TVA-WBN-TS-00-015

**WATTS BAR NUCLEAR PLANT (WBN) - UNIT 1 - REVISION OF BORON  
CONCENTRATION LIMITS AND REACTOR CORE LIMITATIONS FOR  
TRITIUM PRODUCTION CORES (TPCs) - TECHNICAL SPECIFICATION  
(TS) CHANGE NO. TVA-WBN-TS-00-015**

PROPOSED TECHNICAL SPECIFICATION (TS) CHANGE TS-00-015  
AND TPBAR CONSOLIDATION ACTIVITY  
DESCRIPTION AND EVALUATION OF THE PROPOSED CHANGE

Figure 3.7.15-1 Acceptable Burnup Domain - Watts Bar Spent Fuel Storage Racks

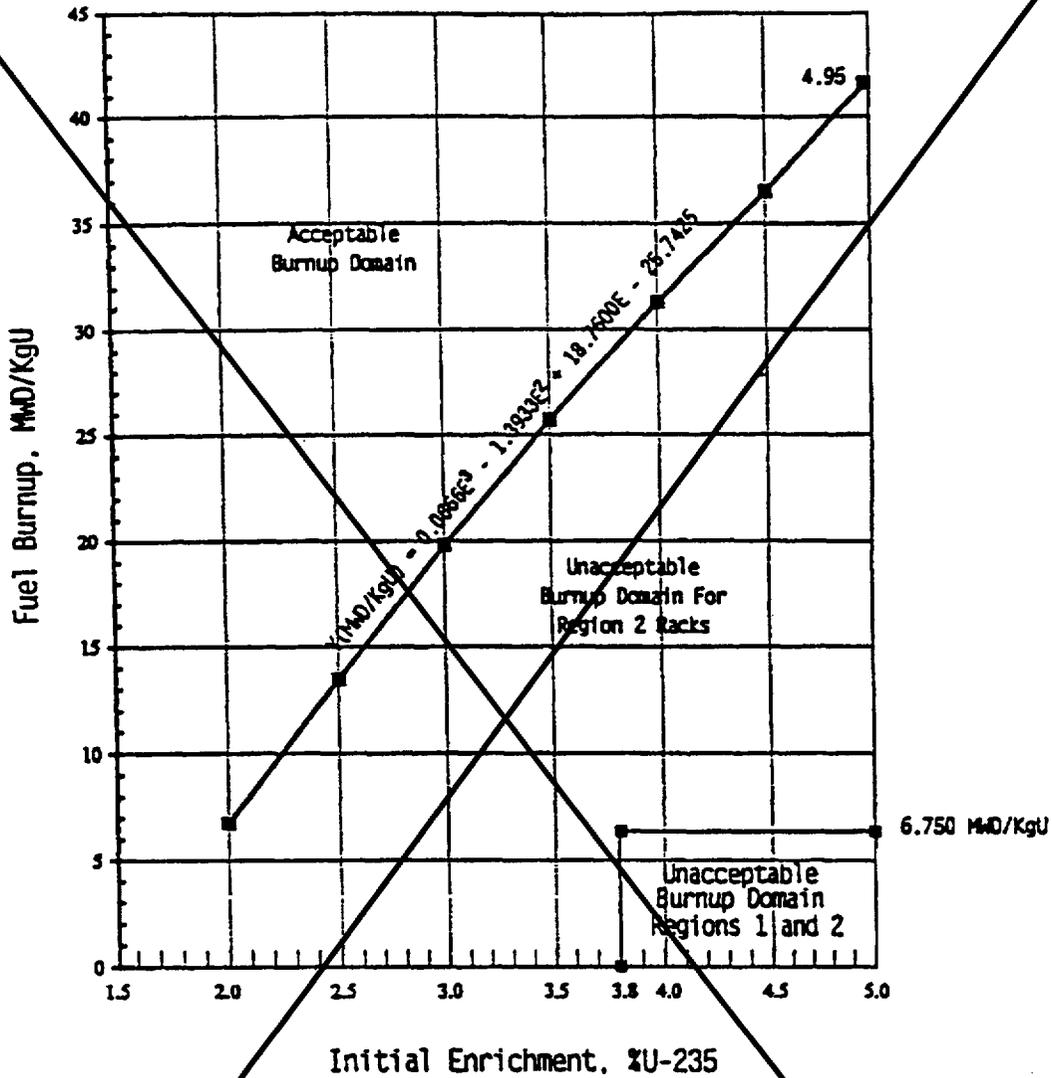
This change is requested to remove reference to Figure 3.7.15-1 and to remove Figure 3.7.15-1 from this section which results in the removal from use of the Region 2 burnup credit racks. As a result, the necessary text changes to the associated TS Bases Pages are being made to reflect the above described removal.

The purpose for removing Figure 3.7.15-1, and the reference to it, is that TVA has determined, since the time that Region 2 burnup credit racks were licensed, that it does not plan to install or utilize this storage option as described by TS section 4.3.3 which is being changed below. As a result, the necessary text changes to the associated TS Bases are being made to reflect the above described removal.

DELETE THIS PAGE

The combination of initial enrichment and burnup of each spent fuel assembly stored shall be in accordance with Specification 4.3.1.1.

FIGURE 4.3-1  
SPENT FUEL STORAGE RACKS

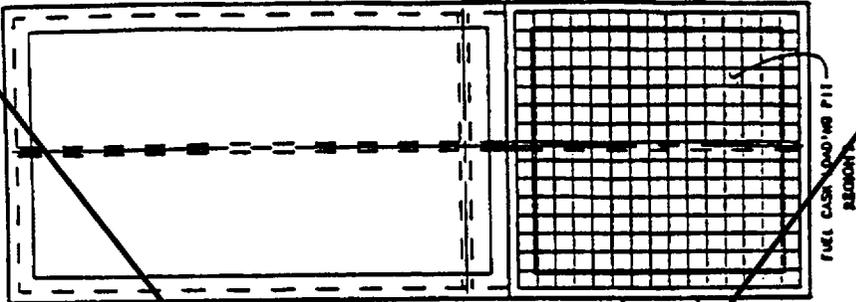
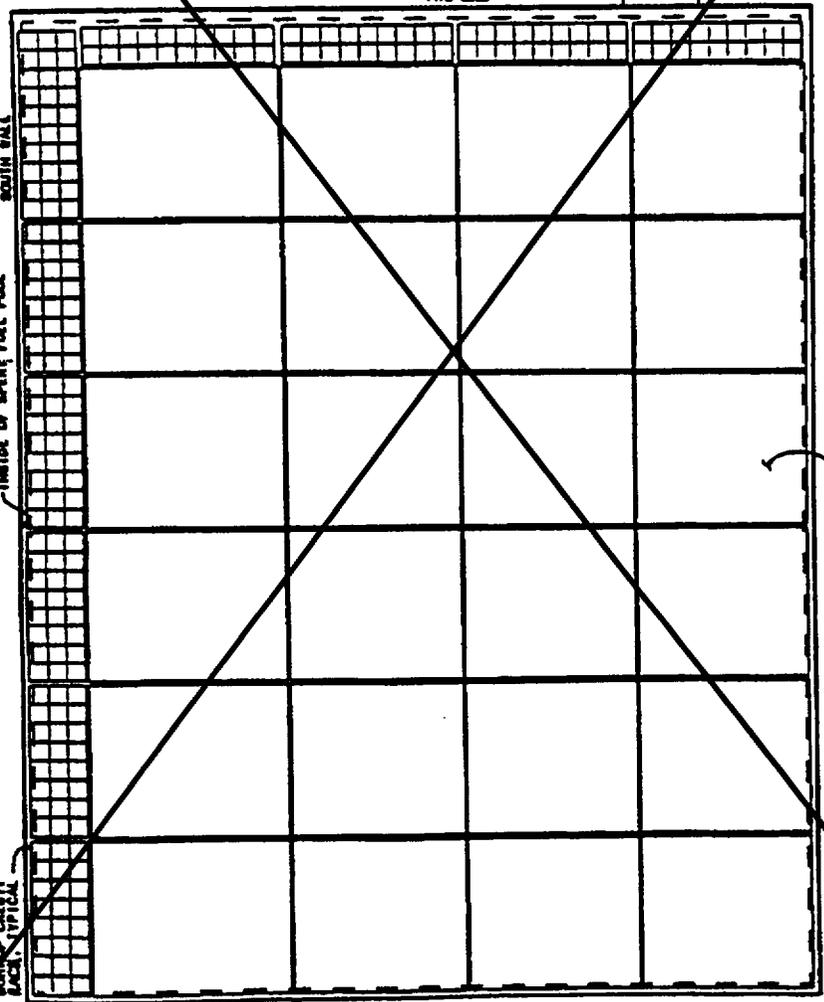
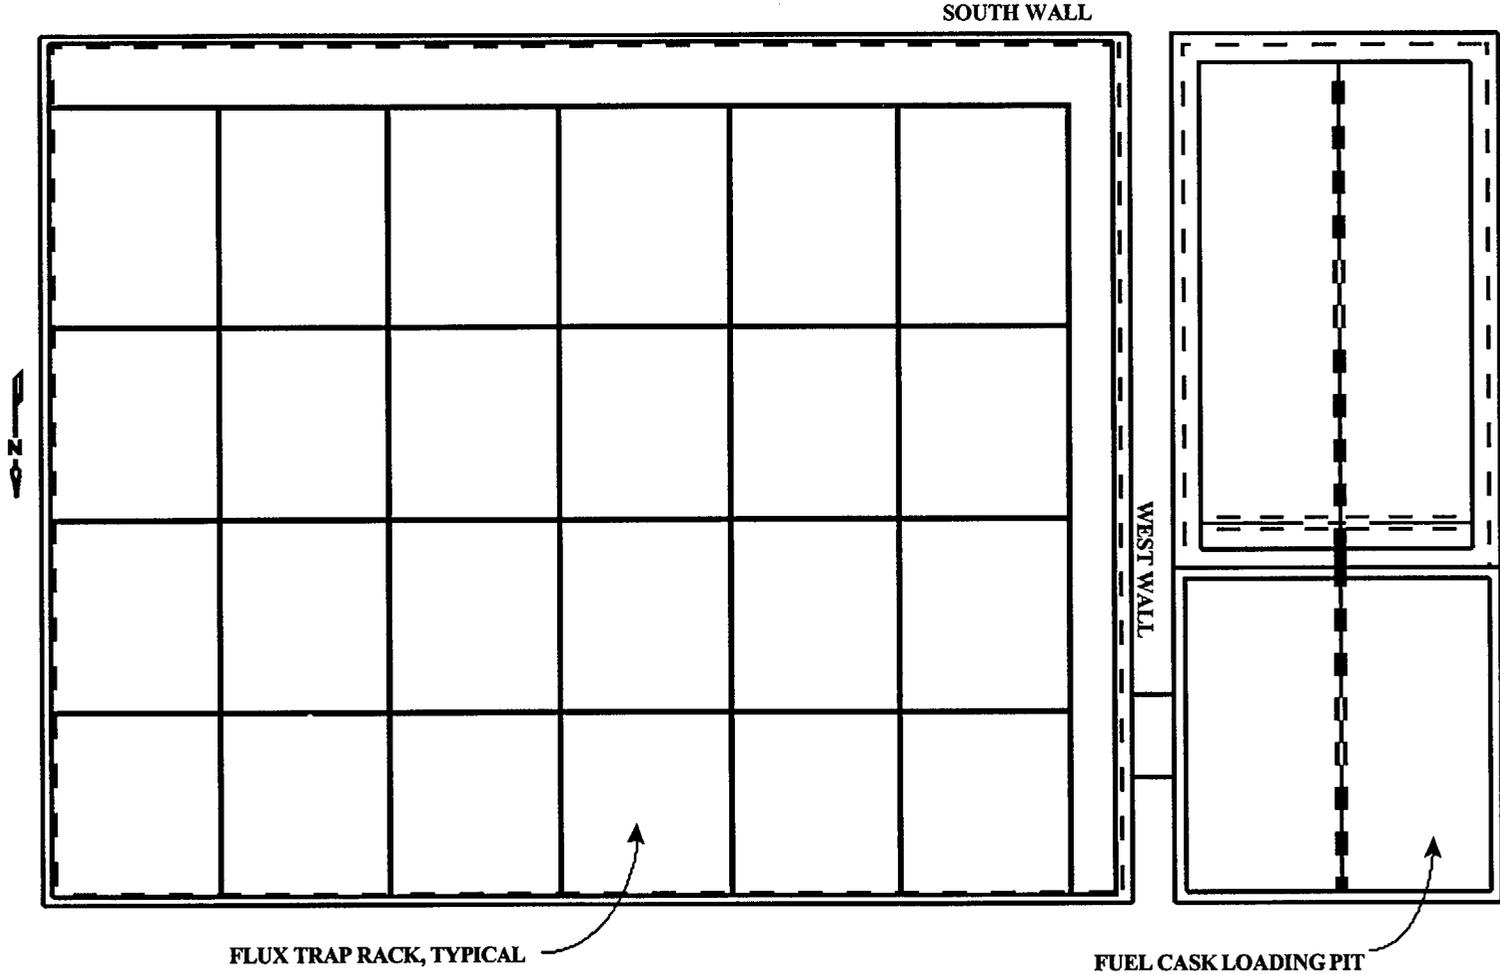
REPLACE WITH NEXT PAGE

INSERT NEW FIGURE

Figure 4.3-3  
Minimum Required Burnup for Unrestricted Storage  
of Spent Fuel of Various Initial Enrichments

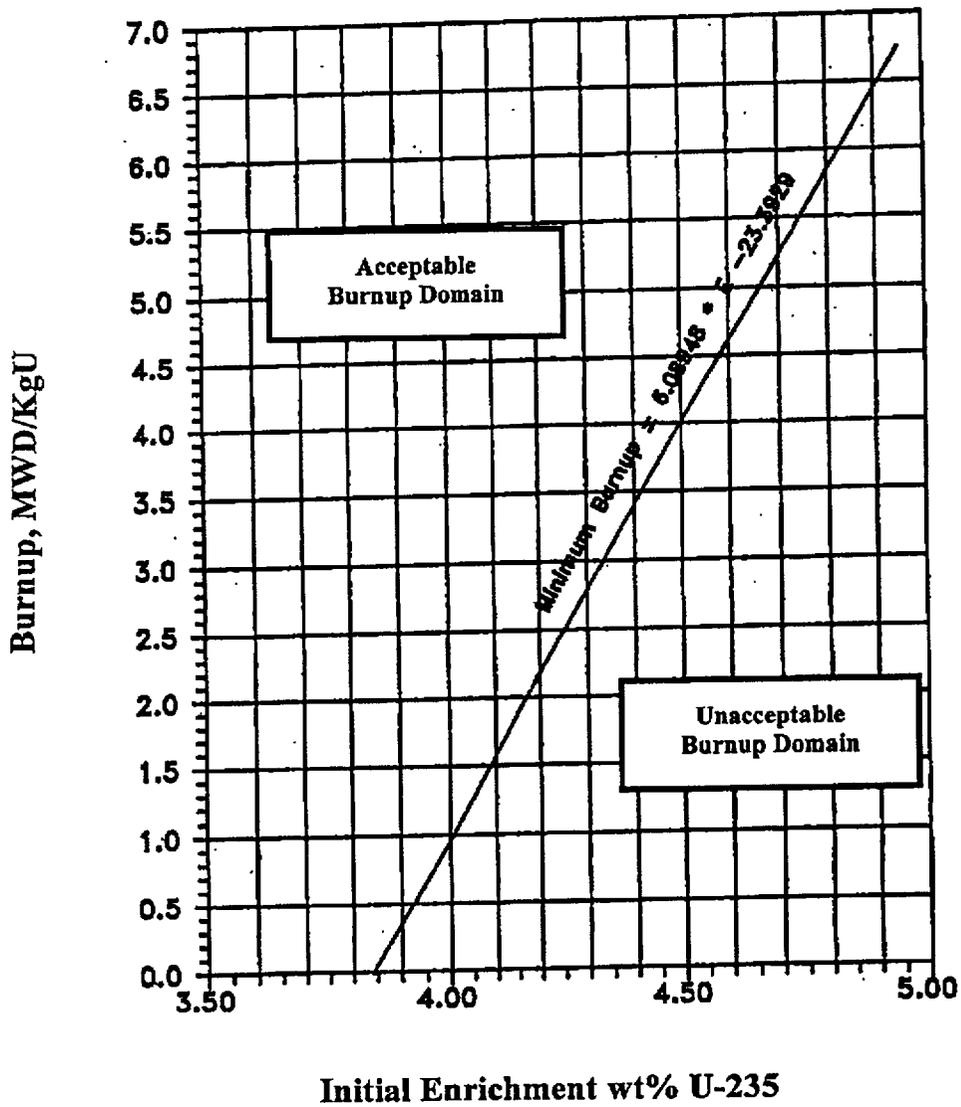
1. Spent fuel assemblies may be stored in the racks without further restrictions provided the burnup of each assembly is in the acceptable domain identified in Figure 4.3-3, depending upon the specified initial enrichment.

INSERT NEW FIGURE

Figure 4.3-4  
Minimum Required Burnup for 2x2 Checkerboard Arrangement of 2 Spent Fuel Assemblies with 2 New Fuel Assemblies of 5% Enrichment (Maximum)

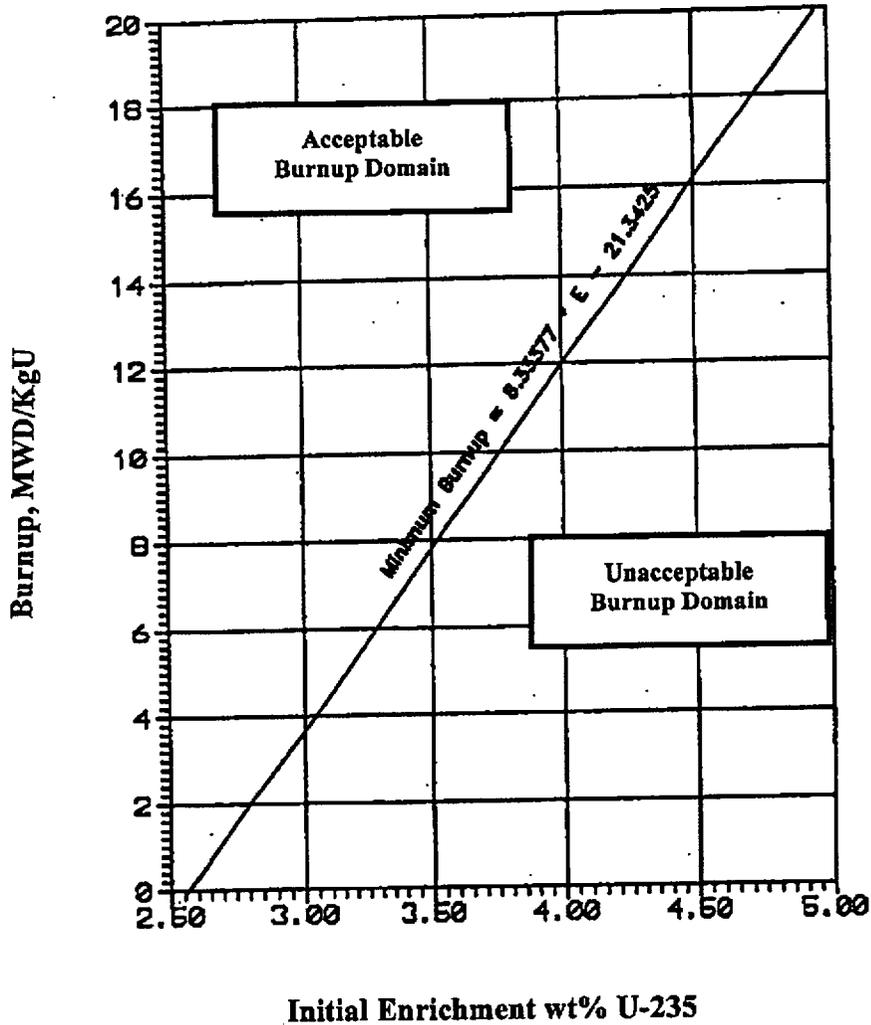
2. New and spent fuel assemblies may be stored in a checkerboard arrangement of 2 new and 2 spent assemblies, provided that each spent fuel assembly has accumulated a minimum burnup in the acceptable domain identified in Figure 4.3-4.

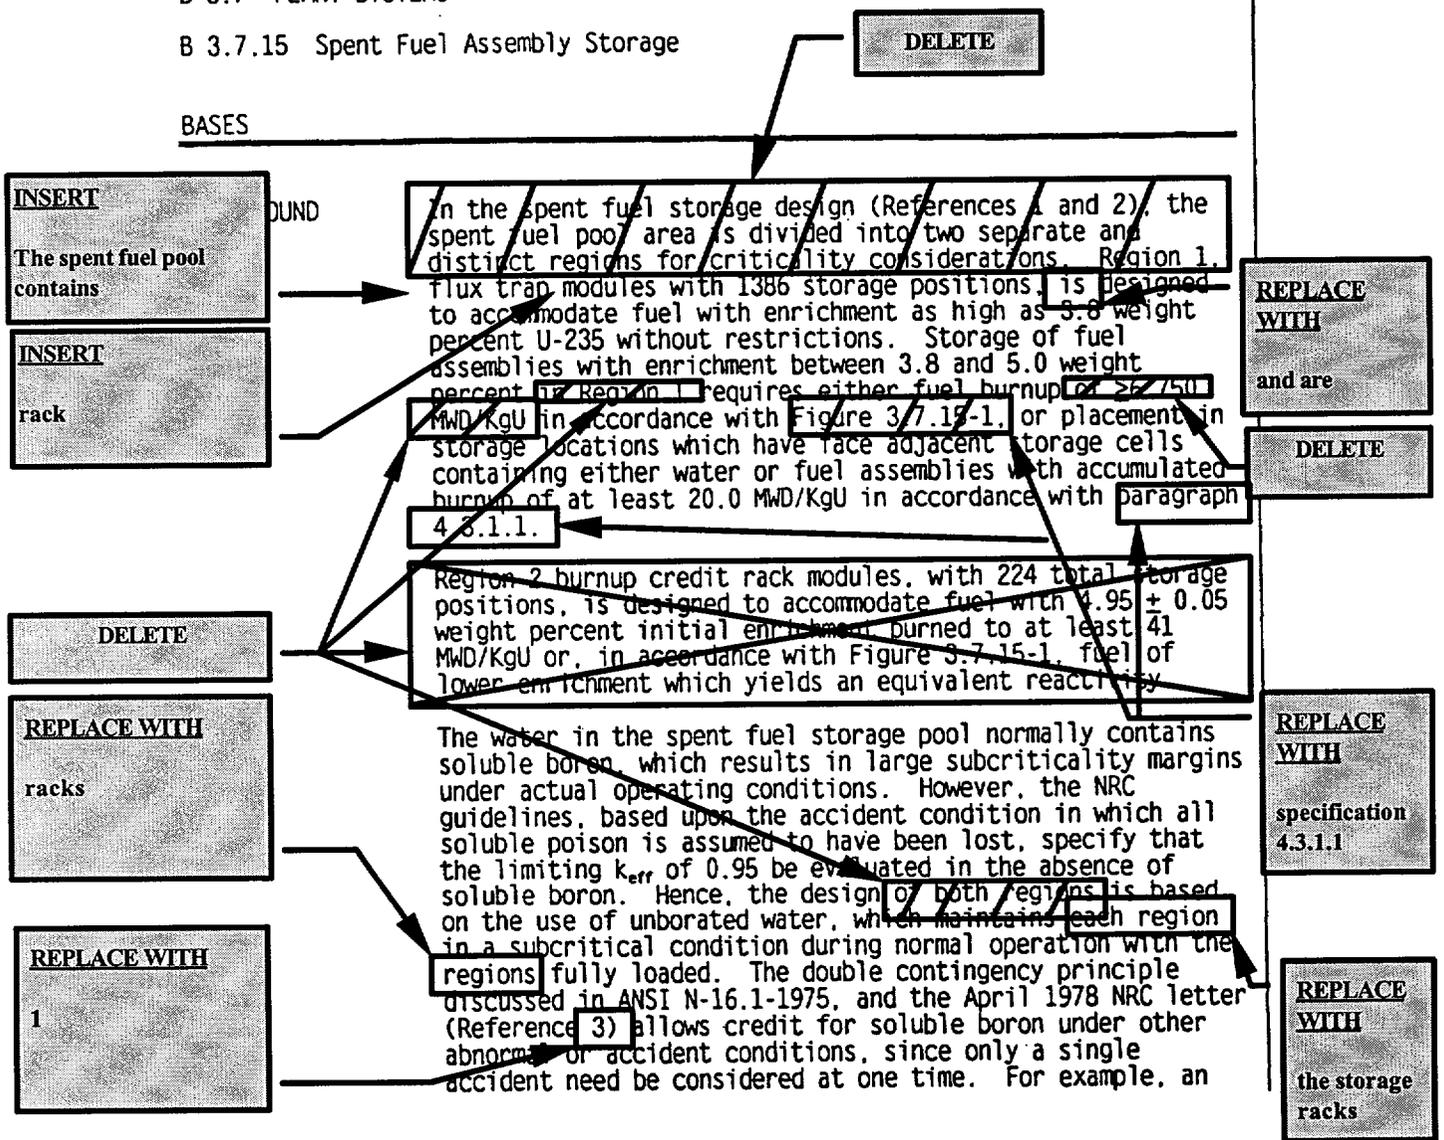
As a result of the tritium program, a change is being made to the TS Bases for hydrogen recombiners to include tritium inside the TPBARs as a possible source. This change would modify items a. and c. on page B 3.6-44 to read as follows:

**REPLACE WITH**  
Based on the conservative assumptions used to calculate the hydrogen concentration versus time after a LOCA, the hydrogen concentration in the primary containment would reach 4.0 v/o in about 3 days if no recombiner was functioning (Ref. 5). Initiating the hydrogen recombiners within 24 hours after a DBA will maintain the hydrogen concentration in the primary containment below flammability limits.

**REPLACE WITH:**  
Hydrogen in the RCS at the time of LOCA (i.e., hydrogen dissolved in the reactor coolant, hydrogen gas in pressurizer vapor space, and tritium contained in TPBARs); or
